RE: Federal Cell Facility Application Request for Information

Federal Cell Application Review

Request for Information or Updates to the Application (RFI)

Appendix B: Federal Cell Facility Engineering Drawings

ENERGYSOLUTIONS
"CLIVE" FACILITY
ENERGYSOLUTIONS SITE FACILITIES
ENVIRONMENTAL MONITORS
CLIVE, UTAH

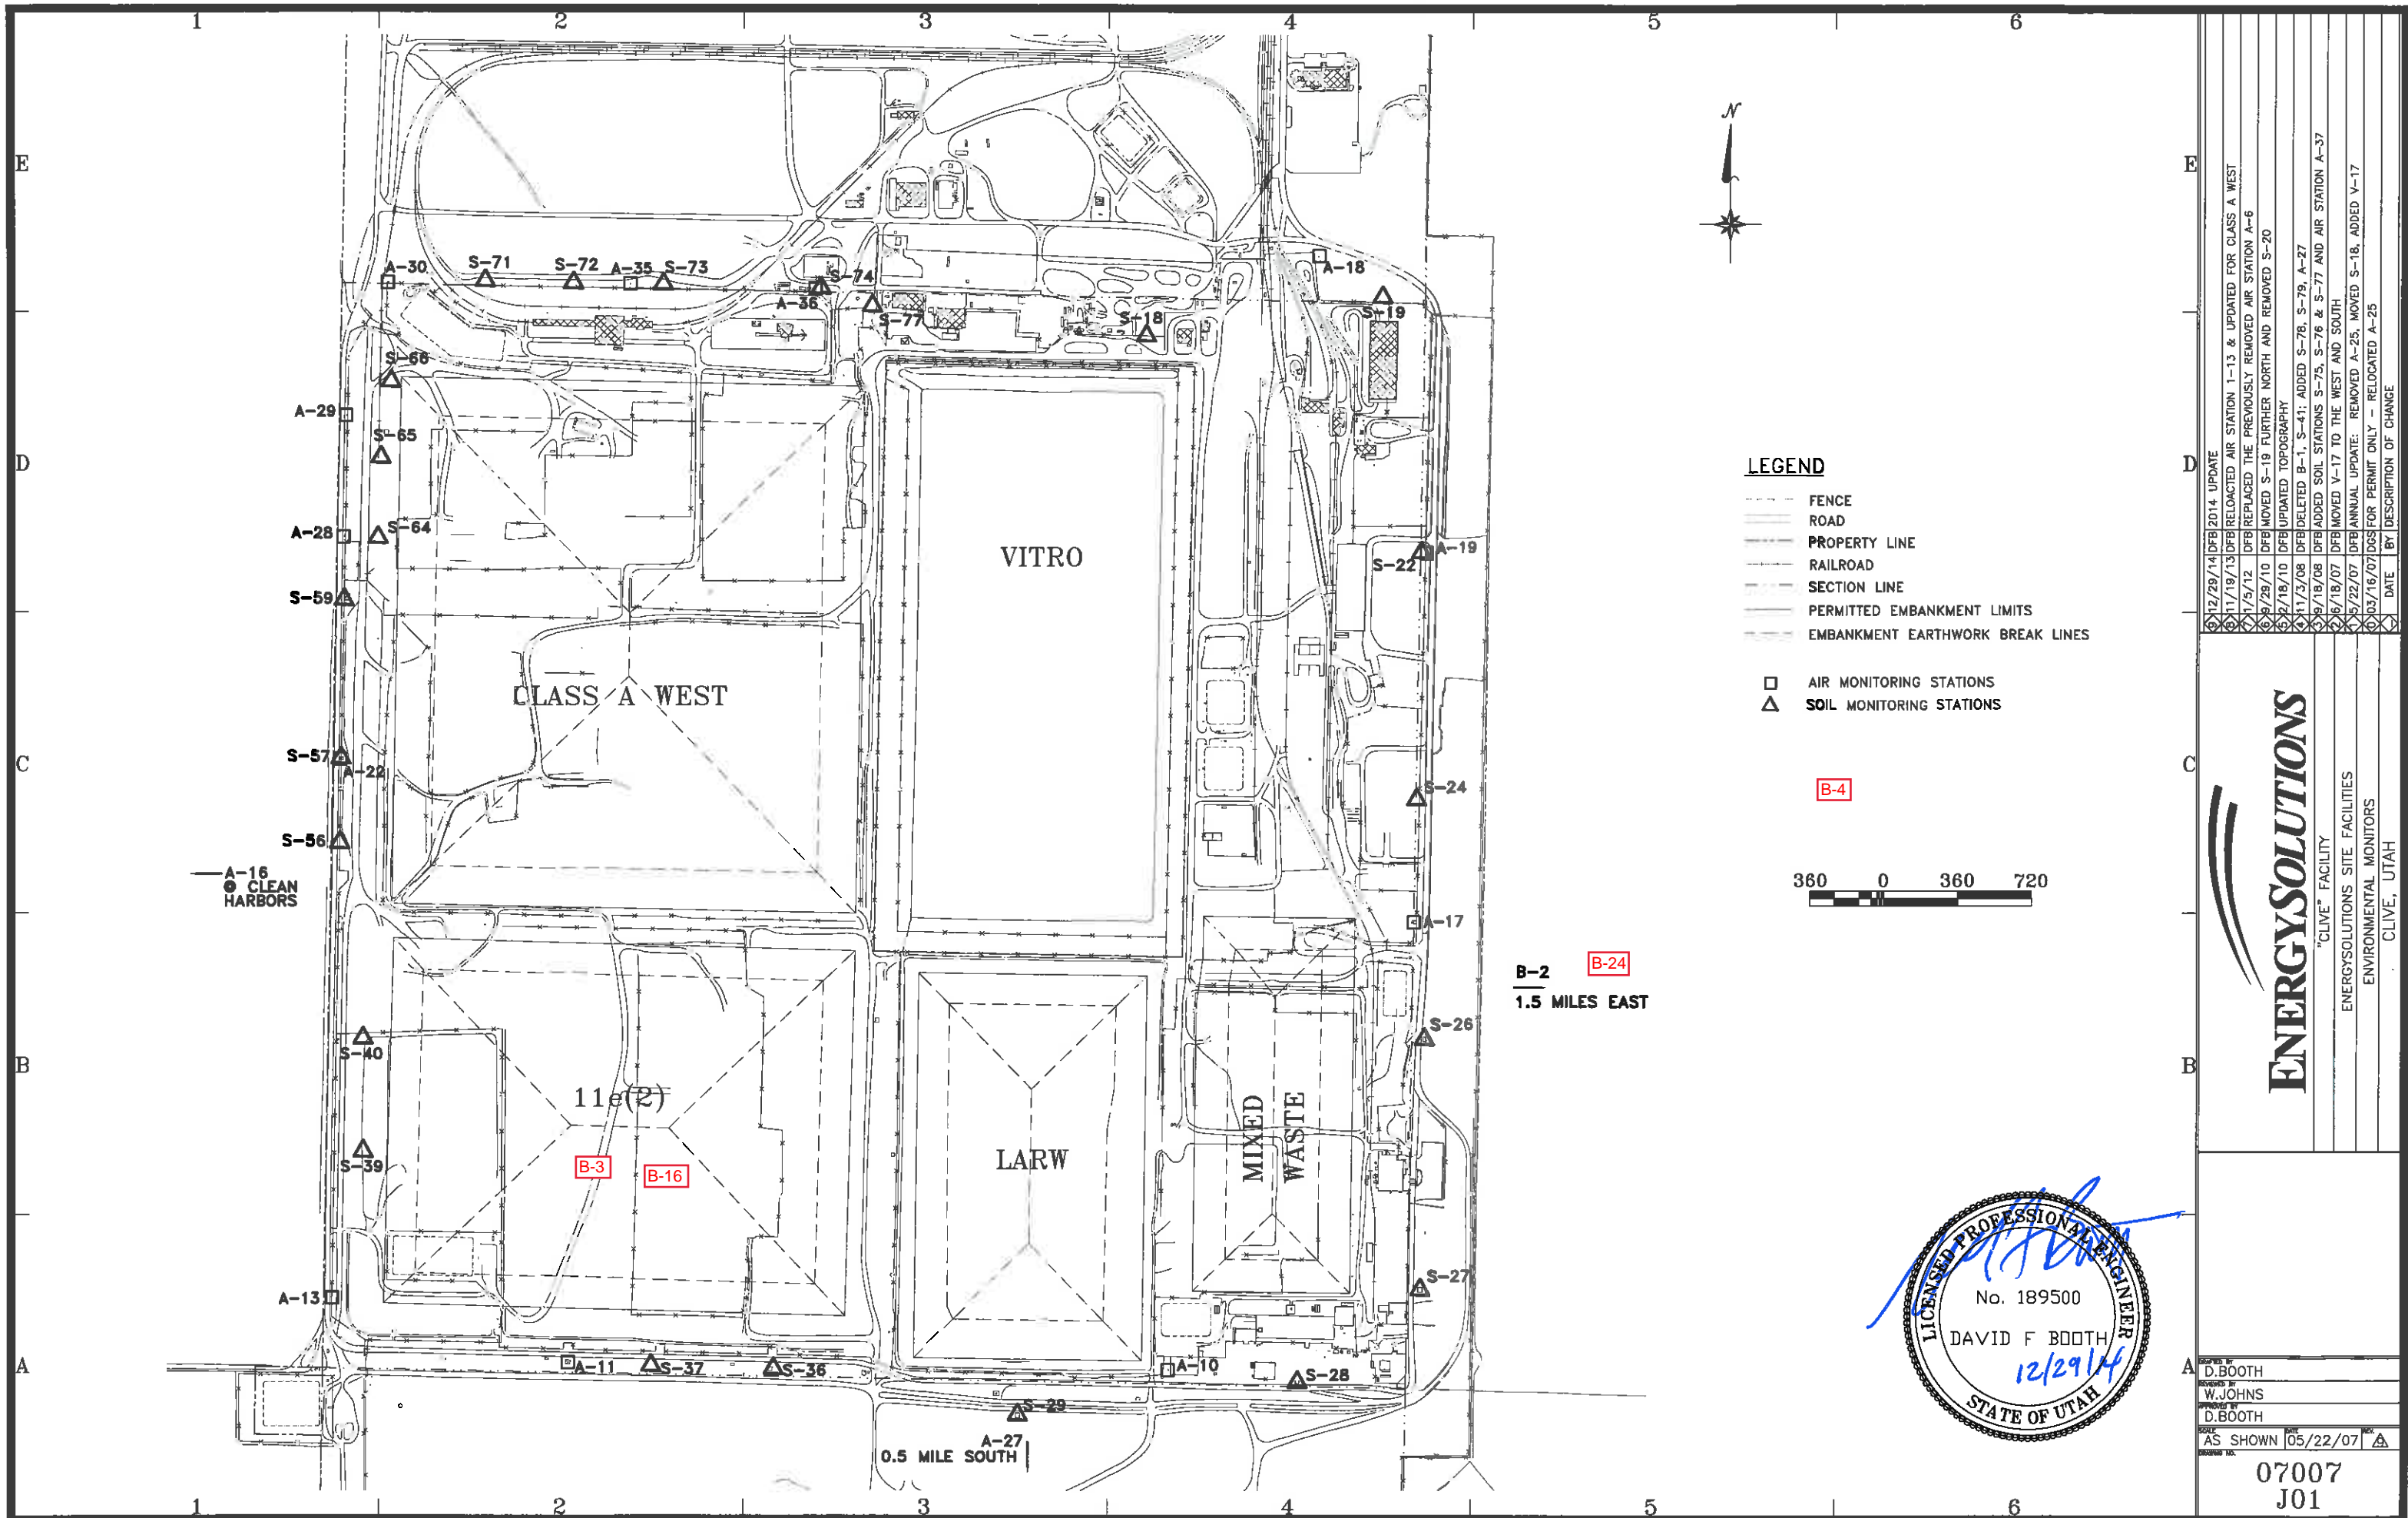
▪ **B-4**

Please provide more detail on the location, purpose, and monitoring device information of B-2. Refer to RFI B-2 as an overarching comment on the lack of detail for specifications on the instrumentation.

"CLIVE" FACILITY
ENERGYSOLUTIONS - SITE FACILITIES
FENCELINE TLDs
CLIVE, UTAH

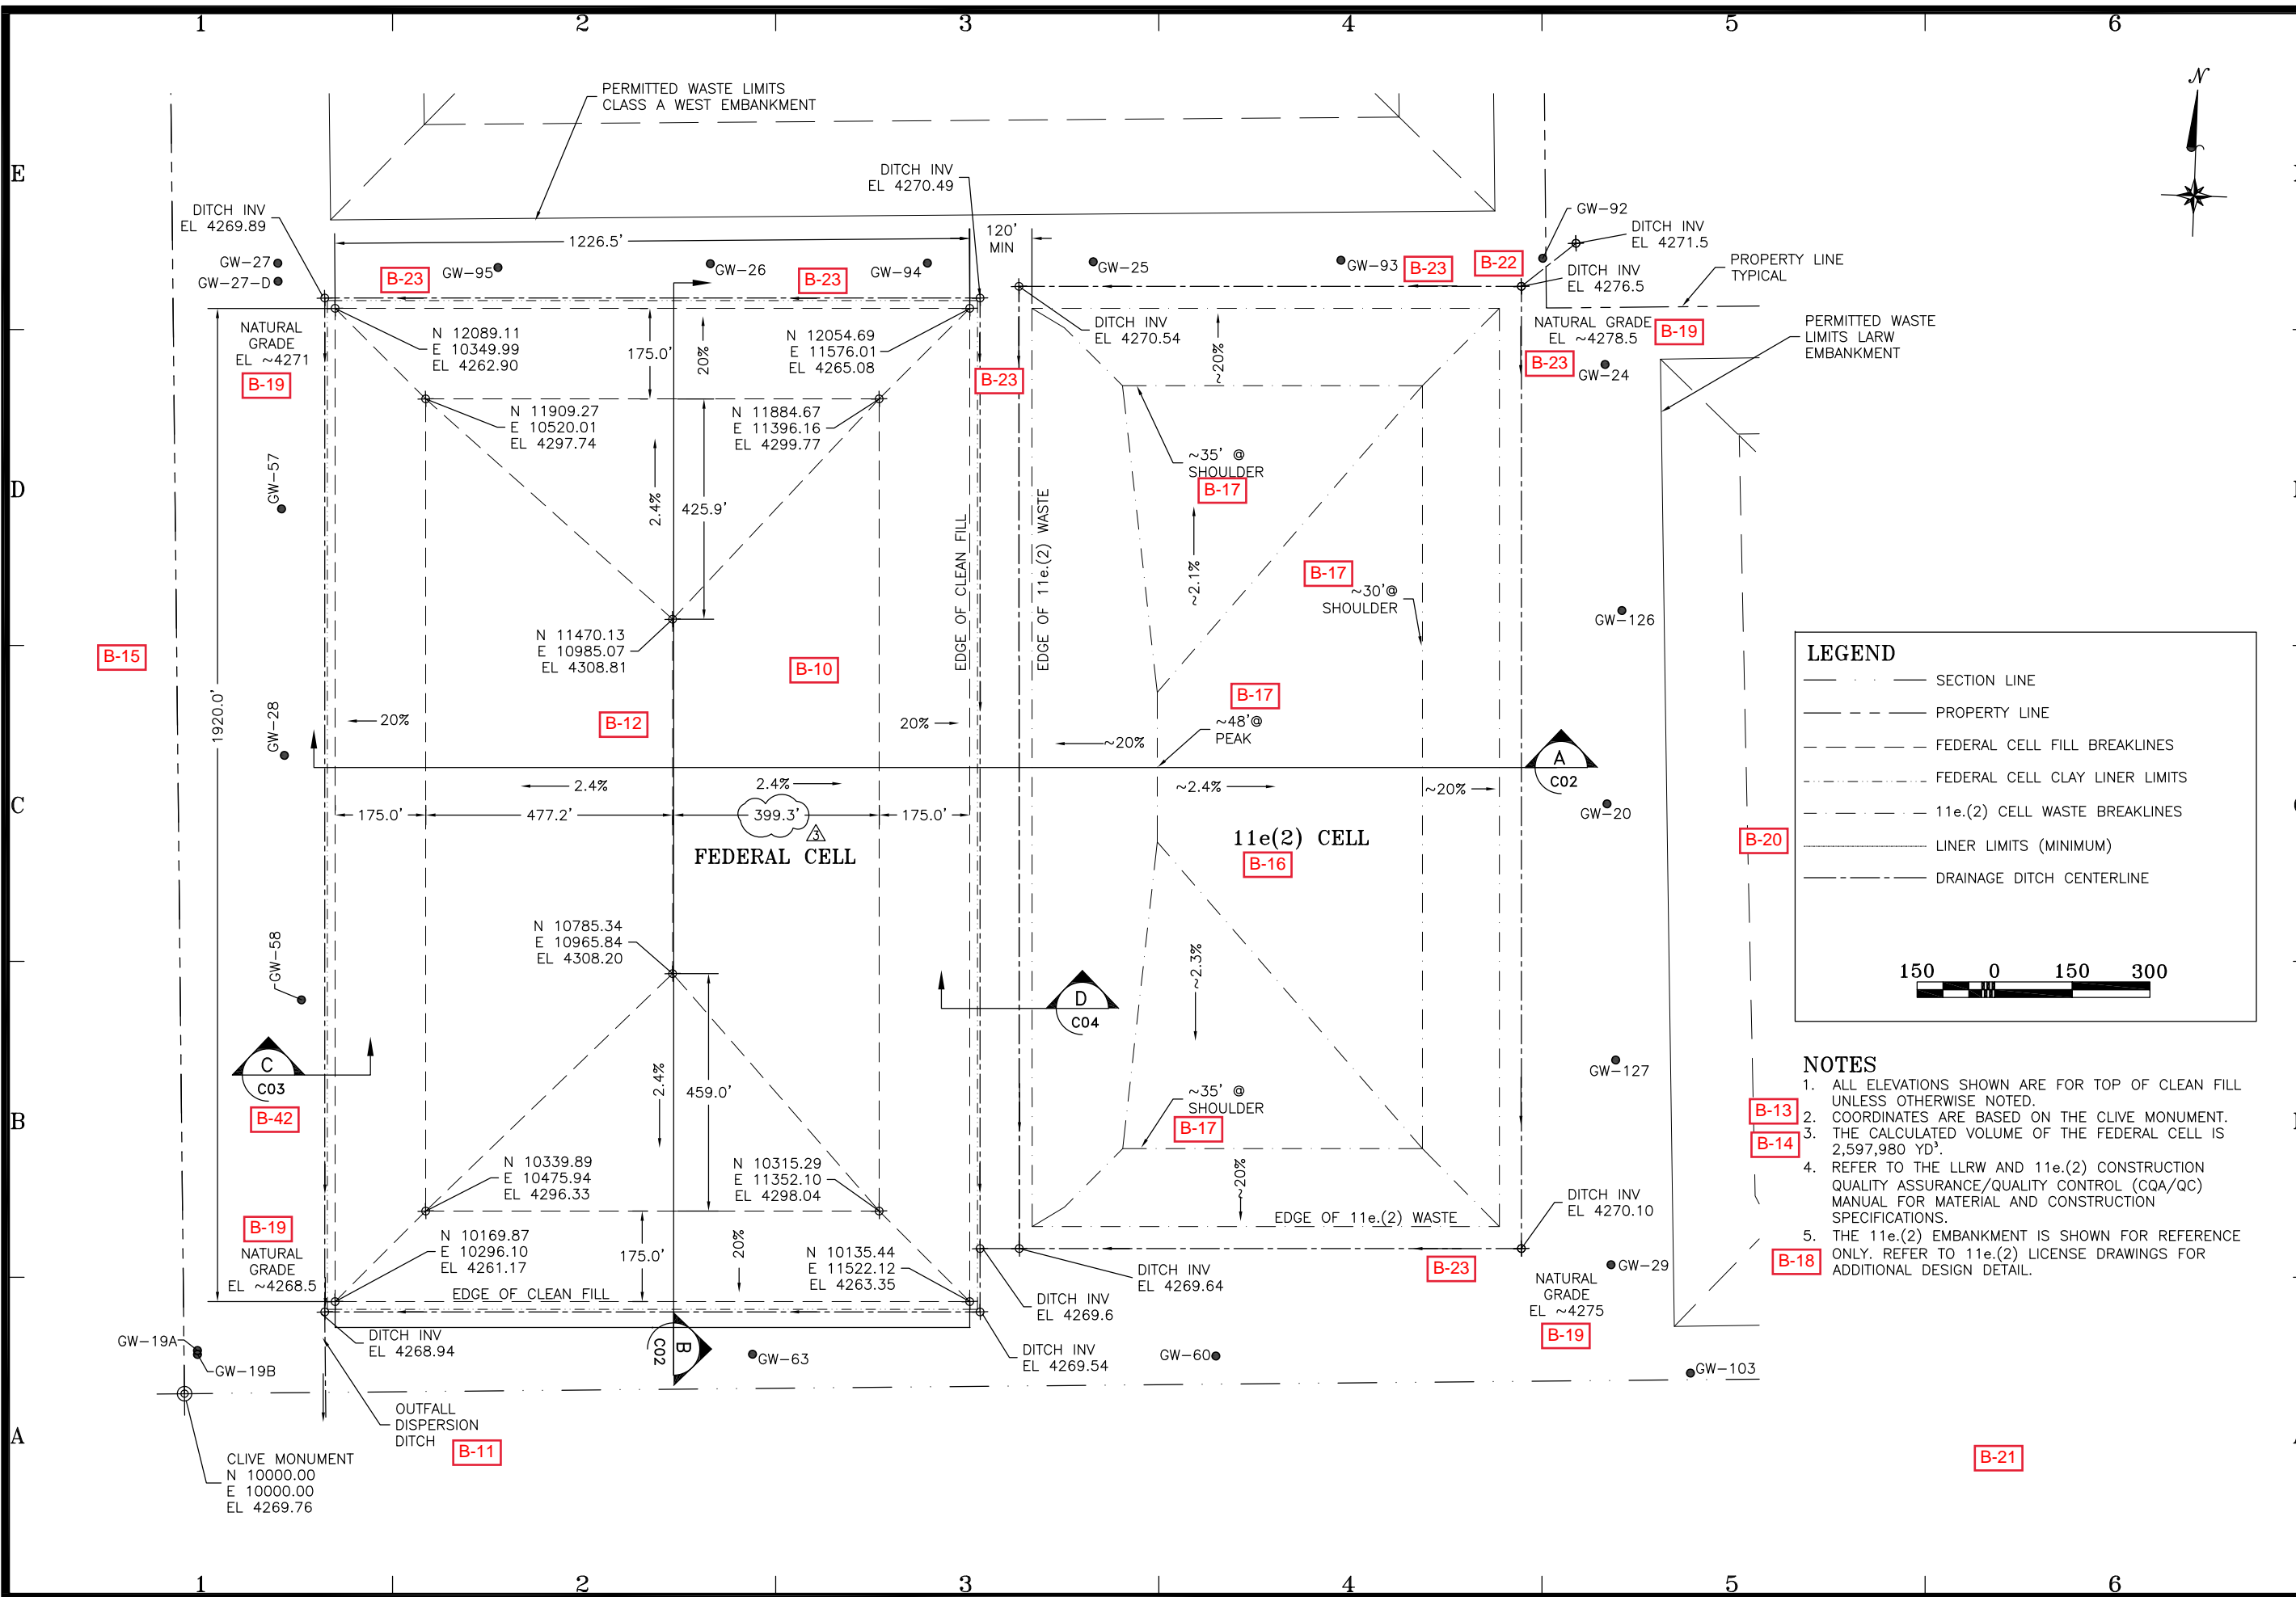
▪ **B-5**

▪ **B-7**

- **B-8**

- a. This line specifically appears to be different than the others (assuming this line is the same as the others).

Please revise sheet to indicate the correct orientation of the North arrow.

- **B-11**

- **B-16**

- **B-21**
